Access Compliance Report Public Rights-of-Way (Curb Ramps)

Intersection ID: 31899 Main Street: MT MANSFIELD RD Cross Street: STOWE DERBY DR Location: Ε **ADA ID: B0A5E64709DC** Ramp Type: PerpDiag Initial Pass/Fail: Fail **Overall Compliance: No Severity Score:** 55

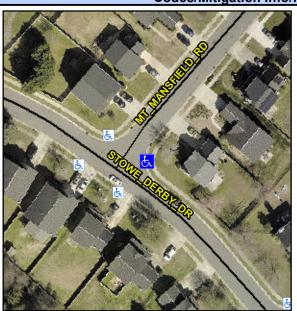
Possible Solutions: Remove & Replace Curb Ramp With Two New Directional Ramps or Equivalent. Surveyor Notes: N/A PROW/ADA: R304.5.1, R304.2.2, R304.5.3

Field Measurements/Component Compliance					
Compliance Description		Data	Comp	liance Description	Data
N/A	Ramp Length (in)	45.0	No	Ramp Slope (%)	12.0
No	Ramp Width (in)	34.0	No	Ramp XSlope (%)	5.6
N/A	Flare Type LT	N/A	N/A	Flare Type RT	N/A
N/A	Flare Slope LT (%)	N/A	N/A	Flare Slope RT (%)	N/A
N/A	Flare Traversable LT?	N/A	N/A	Flare Traversable RT?	N/A
N/A	Landing Length (in)	N/A	N/A	DWS Provided?	N/A
N/A	Landing Width (in)	N/A	N/A	DWS Contrast?	N/A
N/A	Landing Slope (%)	N/A	N/A	DWS Length (in)	N/A
N/A	Landing X Slope (%)	N/A	N/A	DWS Full Width?	N/A
N/A	Landing Curb? (Y/N)	N/A	N/A	DWS Offset (in)	N/A
N/A	Shared Landing?	N/A			
N/A	Gutter Ponding?	N/A	N/A	Gutter Slope (%)	N/A
N/A	Gutter Lip Ht (in)	N/A	N/A	Gutter X Slope (%)	N/A
N/A	Painted X Walk1?	No	N/A	Painted X Walk2?	No
	X Walk 1 Direction	To NW		X Walk 2 Direction	To SW
N/A	X Walk 1 Width (in)	N/A	N/A	X Walk 2 Width (in)	N/A
	X Walk 1 Slope (%)	6.5		X Walk 2 Slope (%)	0.6
